# **Technical Letter Report to the U.S. Nuclear Regulatory Commission JCN Q-4151, Task Order No. 10**

## **Technical Evaluation Report with No Open Items for the Levy County, Florida, COL Review**

Administrative Report, 2011

*Figure 2.4.6.4.5-62. Comparison of free surface elevation time series at the same location, for two different landslide sources - the Mississippi Canyon source and the WORST CASE along the Florida Slope above the Florida Escarpment.*

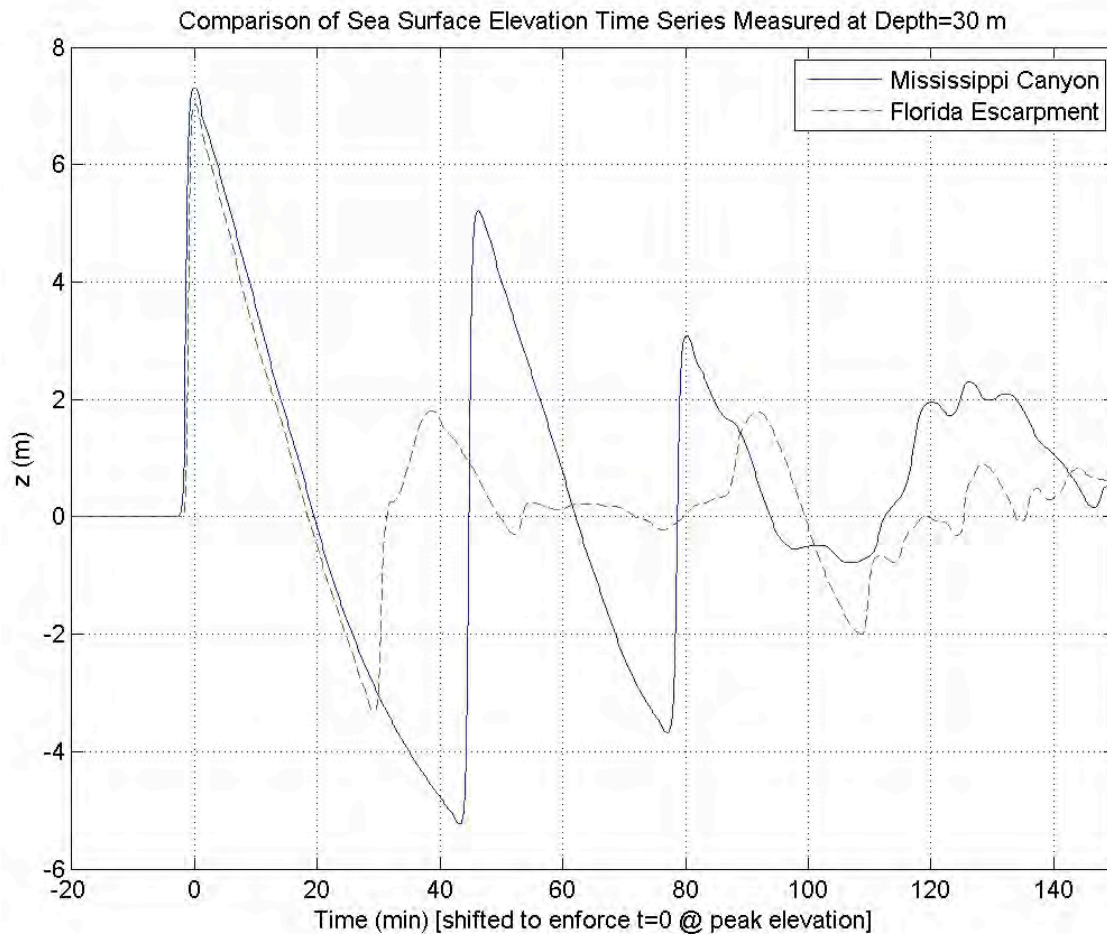
Finally, propagation over the shallow, nearshore bathymetry at the site is examined. The purpose of these simulations is to provide very refined 2HD inundation using the best available bathymetry and topography near the site. This subdomain is nested inside the large-scale 2HD domains discussed above for the Florida Slope WORST CASE and Mississippi Canyon sources. The offshore boundary, situated at a depth of 30 m, is forced with results from the large-scale 2HD simulations. Time series of sea surface elevation from these two simulations, at a depth of 30 m, are shown in Figure 2.4.6.4.5-62. Interestingly, the peak elevations of the wave trains are nearly identical, with the peak Mississippi Canyon crest elevation of 7.2 m, and the peak Florida Slope WORST CASE crest elevation of 6.9 m. The periods of the wave components in these two wave trains are slightly different, with the period from the Mississippi Canyon source at 45 minutes and that from the Florida Slope WORST CASE at 30 minutes. The most significant difference between the two trains is the number of large waves in the train. The Mississippi Canyon wave train has four distinct waves with crest elevation greater than 2 m, while the Florida Slope WORST CASE train has just one. With these comparisons in mind, it is evident that the Mississippi Canyon source produces the PMT for this site, and will be the only source used to simulate the refined, nearshore tsunami impact.
